Coffs Harbour Bypass

Amendment Report

Volume 1A. Executive summary, Chapters 1-4

Figure 2-7 Korora Hill interchange artist's impression looking north

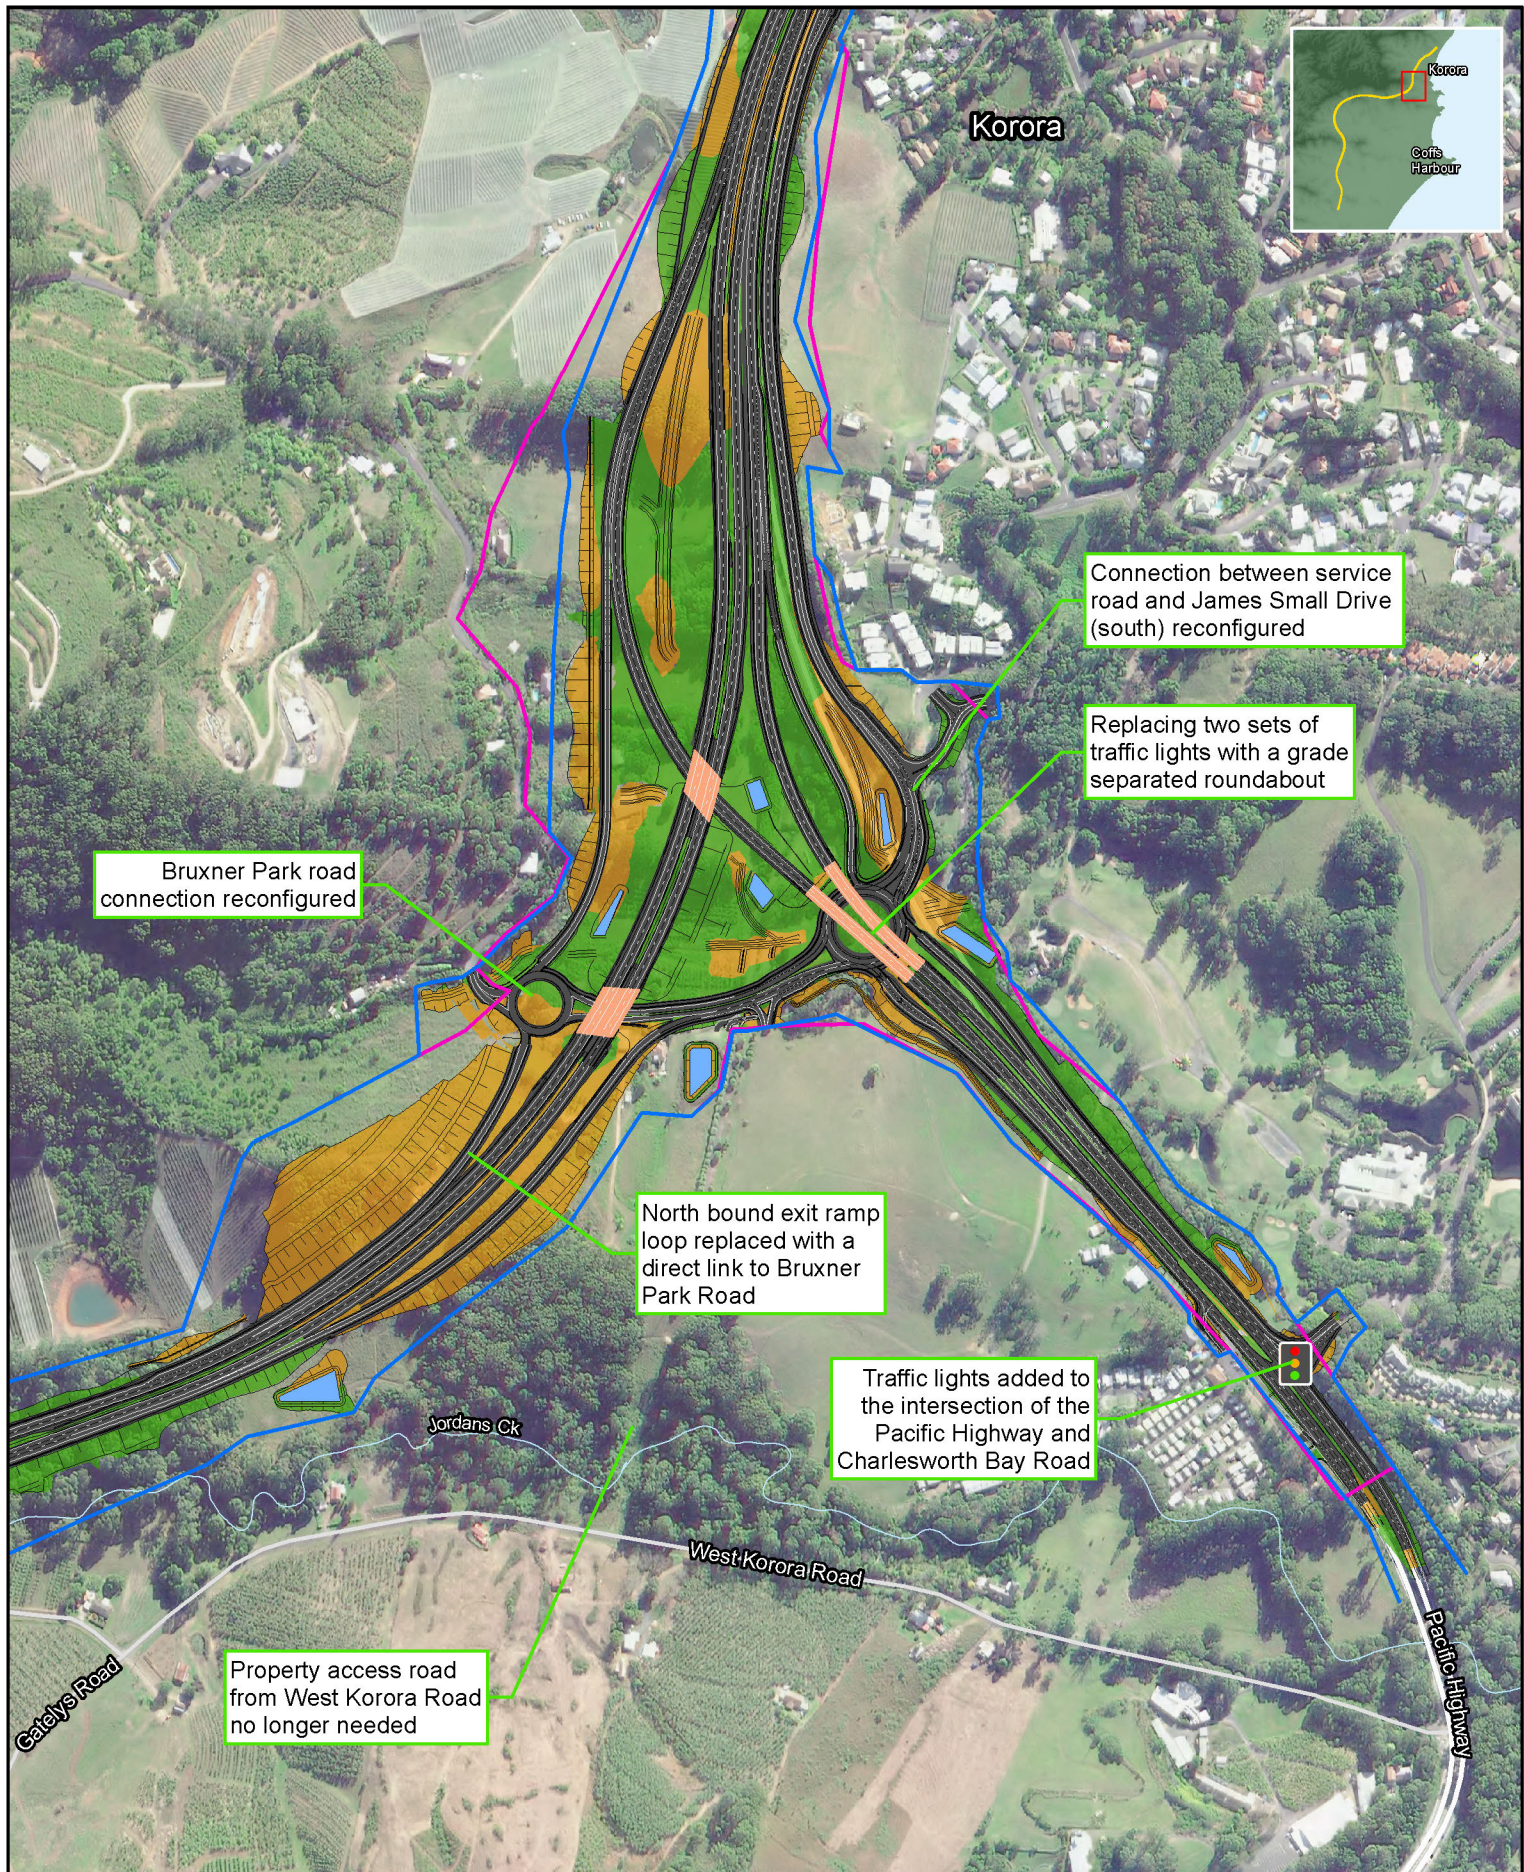
The design changes to the Korora Hill interchange are shown in **Figure 2-8** and an artist's impression of the interchange is shown in **Figure 2-7**. The key features of the interchange comprise:

- A southbound exit ramp from the project to the existing Pacific Highway via a bridge (BR 19) over a roundabout at the intersection of Bruxner Park Road, the service road and slip lanes to and from the existing Pacific Highway. A left slip lane would be provided from the southbound exit ramp to provide access to James Small Drive, the service road and Bruxner Park Road

- A southbound entry ramp from Bruxner Park Road to the project
- A new roundabout would be provided below the northbound entry ramp and the southbound exit ramp to provide access between Bruxner Park Road, the service road, James Small Drive, and the existing Pacific Highway and replace two sets of traffic lights

- James Small Drive would join the service road via a T-intersection
- Traffic lights would be provided at the intersection of the existing Pacific Highway and Charlesworth Bay Road to provide safe access for traffic from Charlesworth Bay Road travelling north.

Figure 2-9 Kororo Public School bus interchange visualisation looking north-east

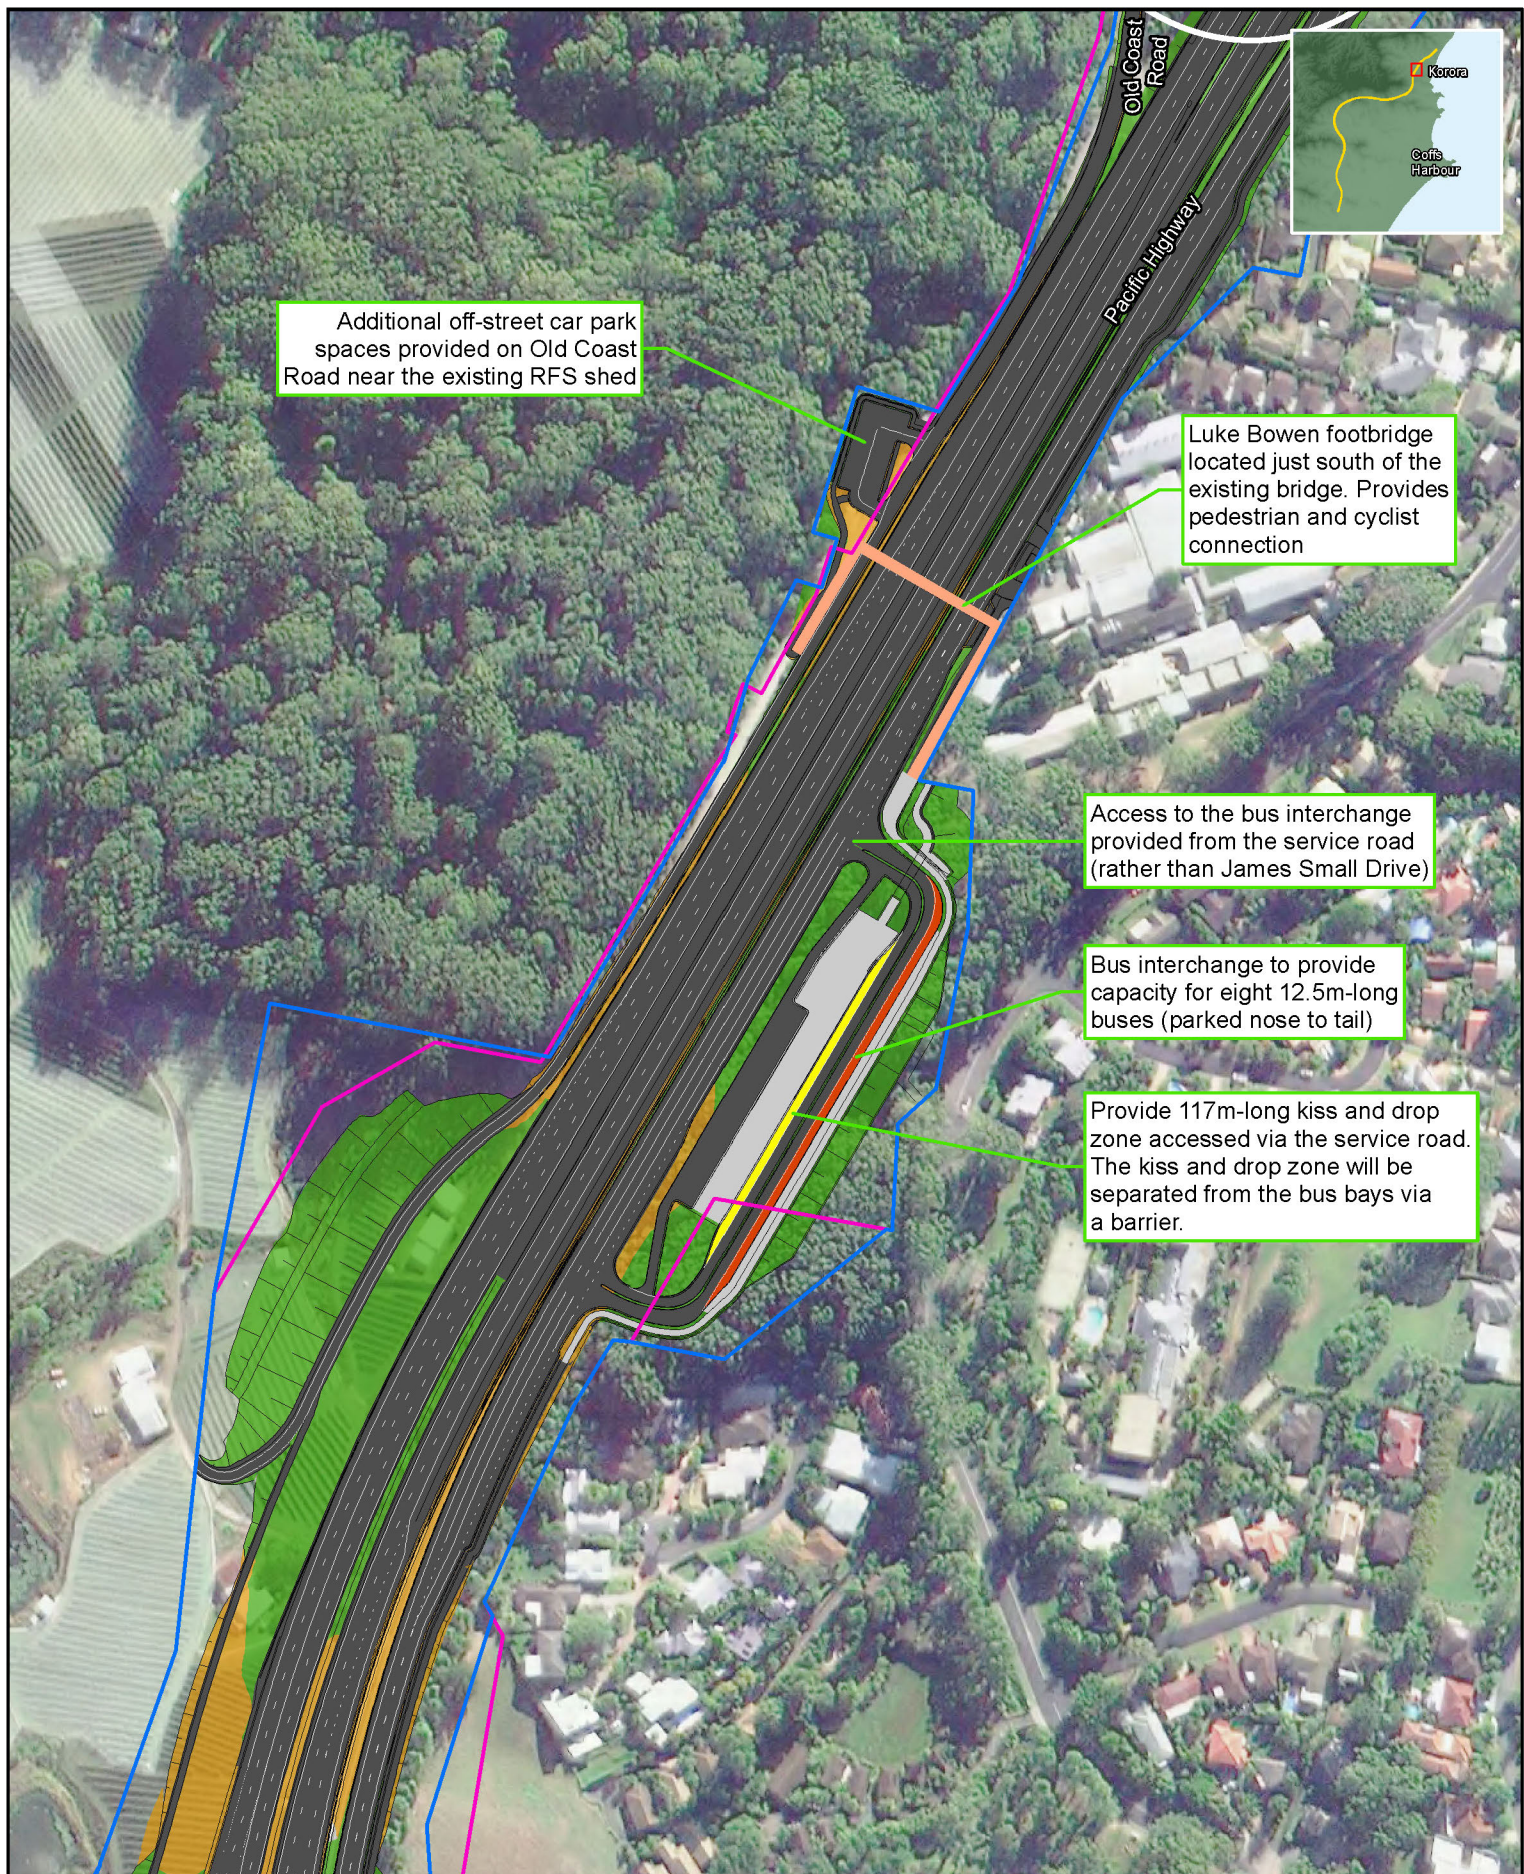
Design changes to the Kororo Public School bus interchange and Luke Bowen footbridge are shown in **Figure 2-10**. An artist's impression of the Kororo Public School bus interchange and Luke Bowen footbridge is shown in **Figure 2-9**. The design changes comprise:

- The Luke Bowen footbridge would be replaced with a new steel arch bridge over the project located just south of the existing bridge and closer to the main entrance of the school. The new bridge would retain the name Luke Bowen footbridge and would be a sympathetic design to complement the old bridge. This bridge would provide a pedestrian and cyclist connection between Old Coast Road and the service road next to Kororo Public School

- Additional off-street short-term and long-term car park spaces would be provided on Old Coast Road near the existing Solitary Rural Fire Services (RFS) shed

- The existing Solitary RFS shed would be directly impacted to accommodate the additional car park spaces and the new footbridge location. TfNSW have commenced consultation with RFS Mid North Coast Team and identified a location near Korora Hill interchange for a new shed and facilities on TfNSW owned property (within construction ancillary facility site 3B, see **Figure 3-1-05**). The new shed and facilities are proposed to be constructed as part of the project and would be undertaken as a pre-construction activity as described in Section 6.4.1 of the EIS. TfNSW will continue to consult with RFS Mid North Coast Team to confirm any additional requirements.

Coffs Harbour Bypass
Pine Brush Creek and Williams Creek realignment
Figure 2-11

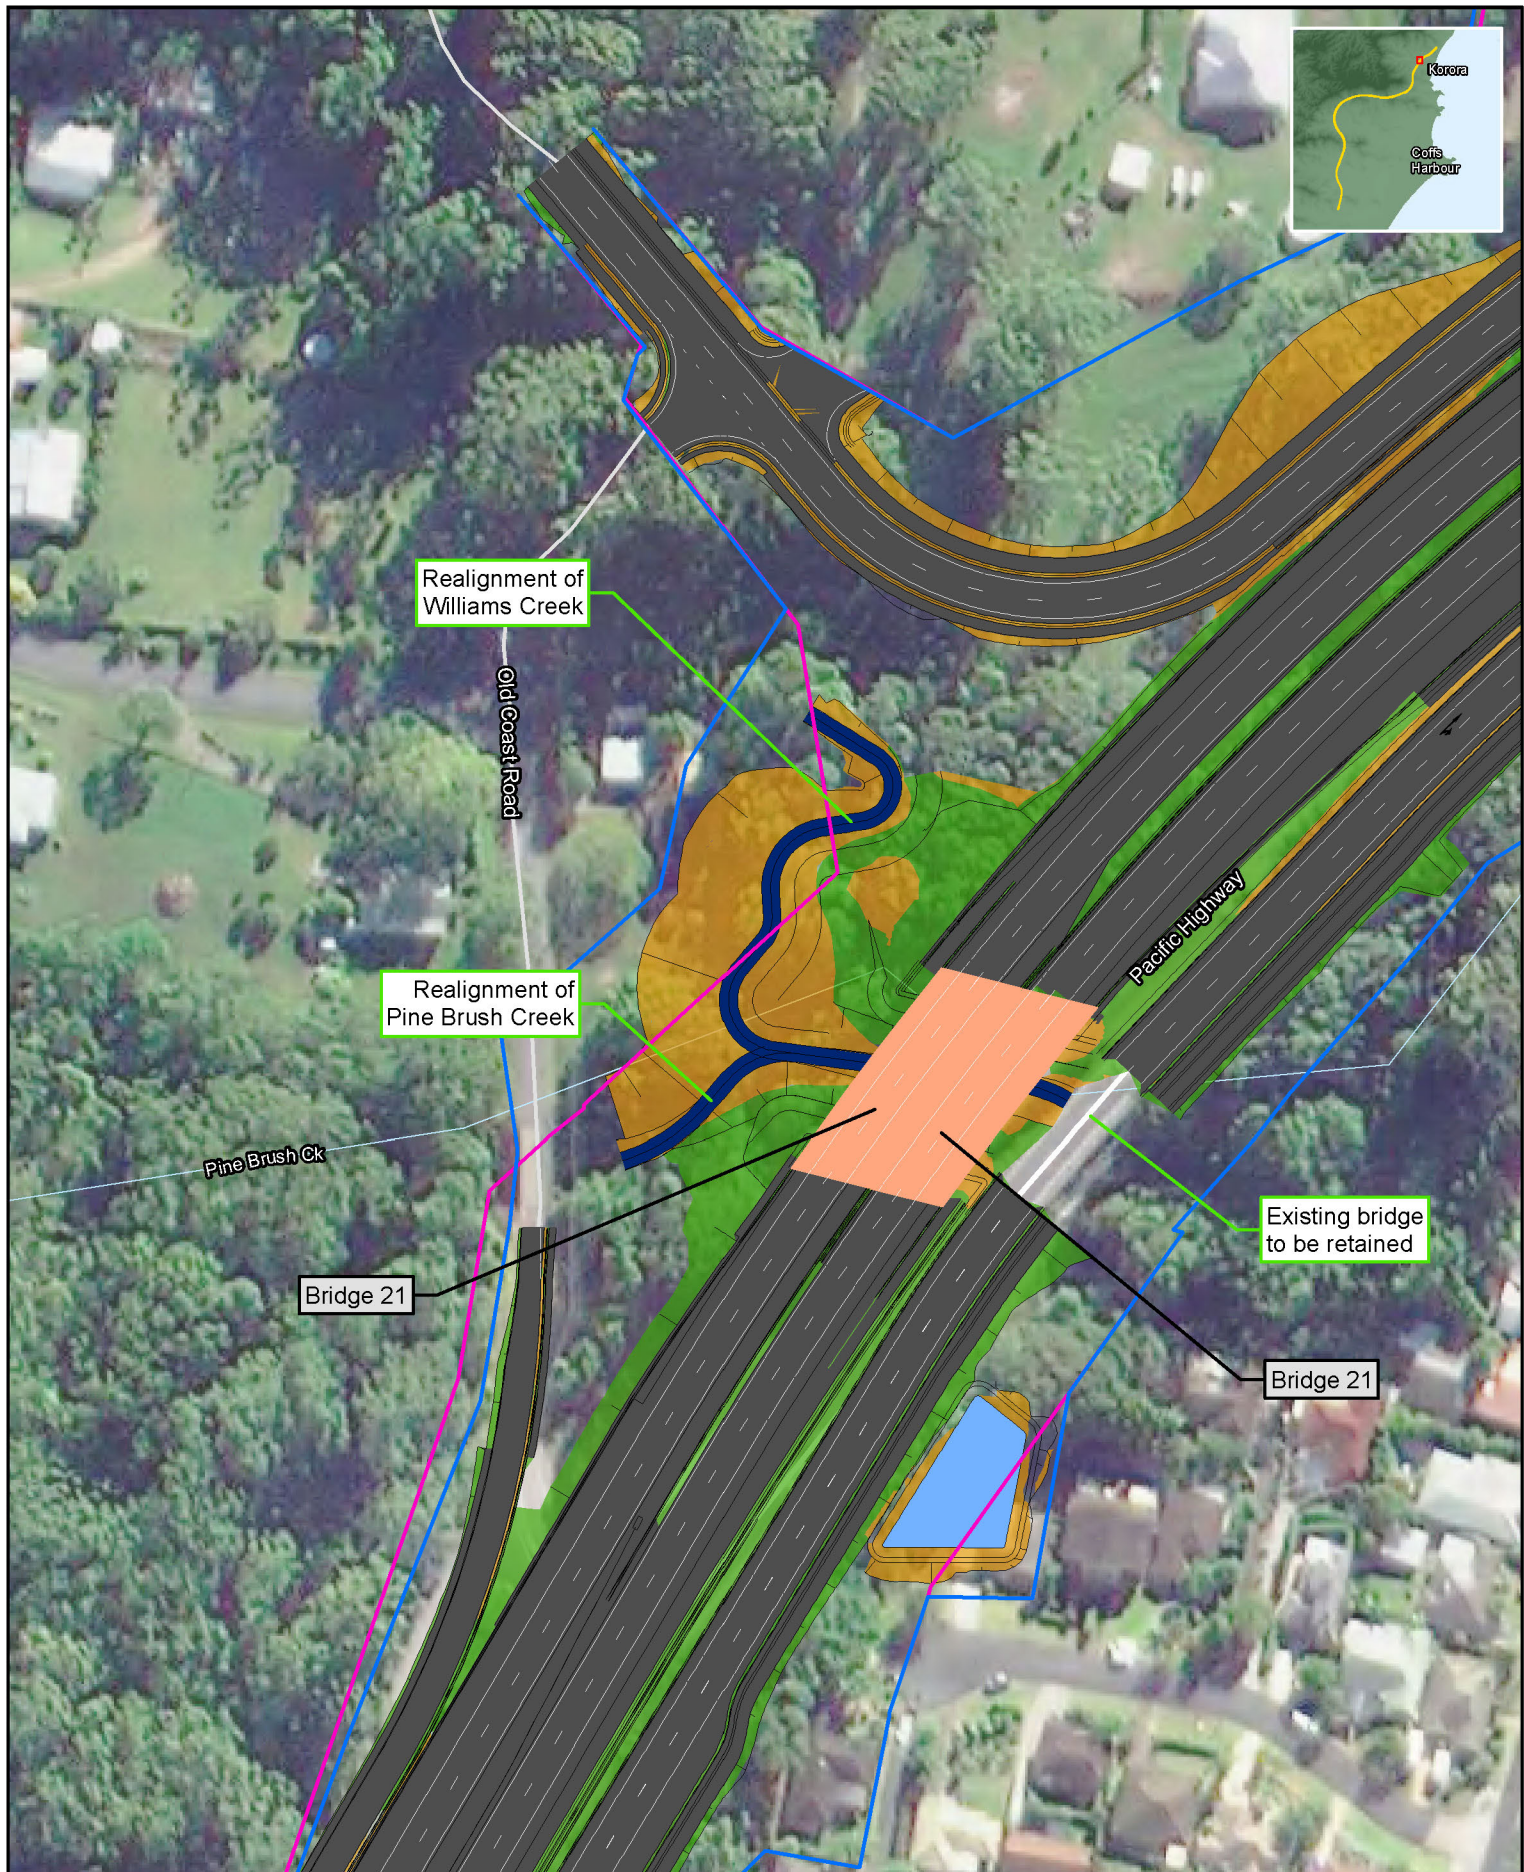
Design changes to the Pine Brush Creek and Williams Creek realignment are shown in **Figure 2-11** and include:

The new northbound and southbound highway bridge over Pine Brush Creek (BR 21) has also been refined as a result of the design investigations for Pine Brush Creek and Williams Creek realignment. The bridge length has been reduced from an indicative length of 40 metres in the EIS to 37 metres and is now proposed to be a single span bridge compared to a two span bridge described in the EIS. The bridge would be designed for fauna passage as described in the EIS. There has been no change to the retention of the existing southbound bridge which would be used as part of the new service road.

- Pine Brush Creek is identified as a Class 1 waterway and has been realigned to provide a waterway length similar to the existing waterway length and to minimise hard engineering treatments and concrete channelisation of the waterway

- To ensure the new bridge structures and the retained southbound bridge are protected and road user risks minimised and as well as to minimise erosion and scour in the creek next to the bridge structures, the confluence of Pine Brush Creek and Williams Creek need to be relocated further upstream from the new bridge (BR 21). This assists in providing acceptable hydraulic performance (eg flow direction and velocity) of the waterway as it flows under the new and retained bridges
